U-6A / NU-1B System

Aircraft Inspection Report

December 19, 2003

Document Number: 2003 NU-1B 0001

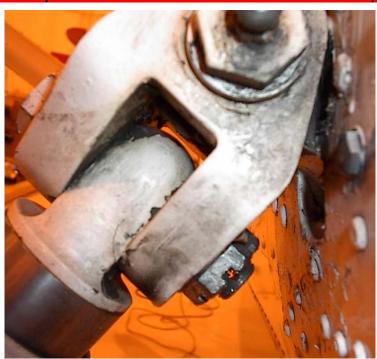
5.4.1.2. Check parking brake valve for hydraulic leak (fluid residues on valve).

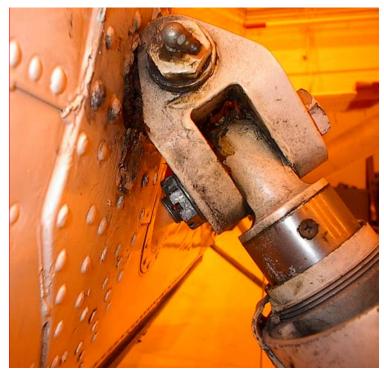
5.4.1.3. Aft fuel feed tube is chafing on sump plate bolt head in area of MLG drag struts---requires inspection. Possible replacement if beyond 10% wall thickness.

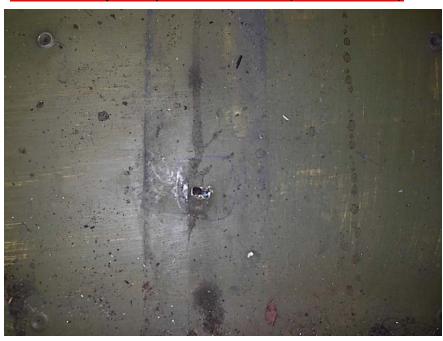
5.4.1.5. No cotter pins on L/H and R/H shock strut to fuse attach points

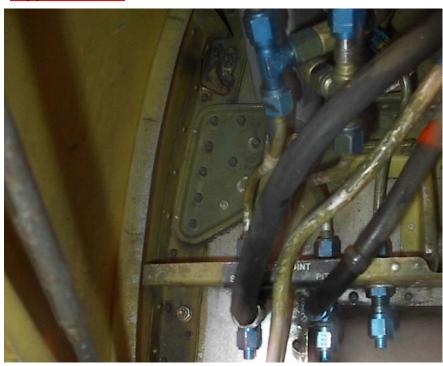
5.4.1.6. 3 cracked sleeves on 3 separate hyd. lines leading to flap jack. 1 line currently leaks.

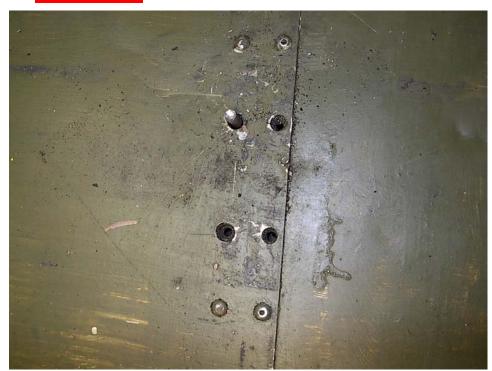
5.4.1.8. Crack on LH Aft side of firewall directly opposite of engine cowling support bracket.

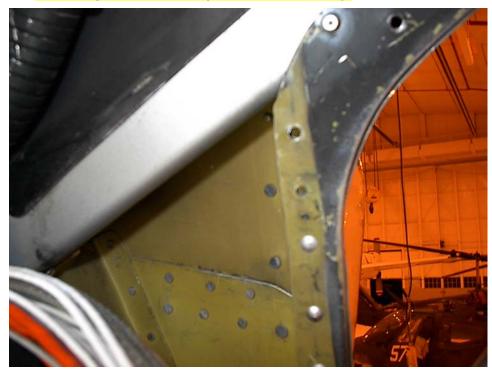
5.4.1.16. 6 missing rivets, Co-pilot side behind radio panel, under co-pilot window retaining strip.

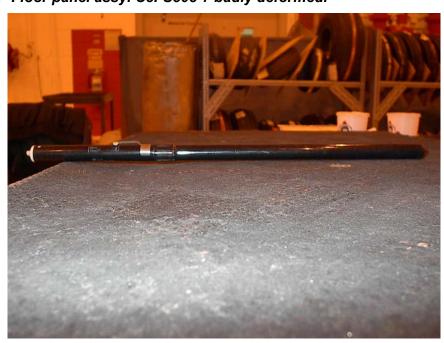
5.4.1.31. 2 unapproved repairs to STA 83.25 Lwr R/H former not I.A.W. SRM Fig. 4-9 pg.63 SRM.

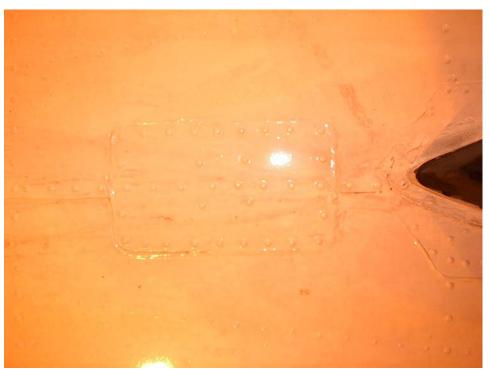
5.4.1.34. Floor panel assy. C3FS308-7 badly deformed.

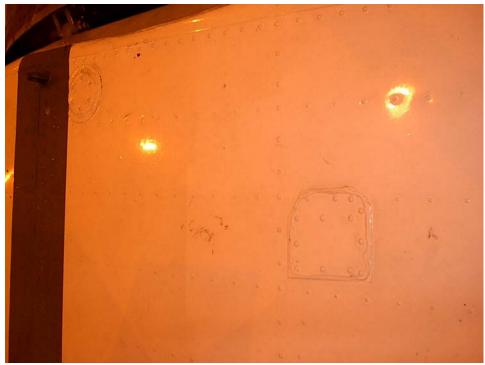
5.4.1.36. Non-standard (unapproved) repairs to cabin roof top from station #224 to station #264.

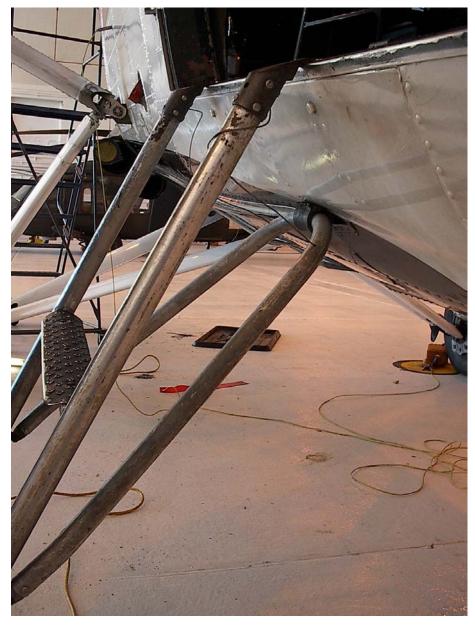
5.4.1.39. Dirt and FOD found under cabin sub floor.
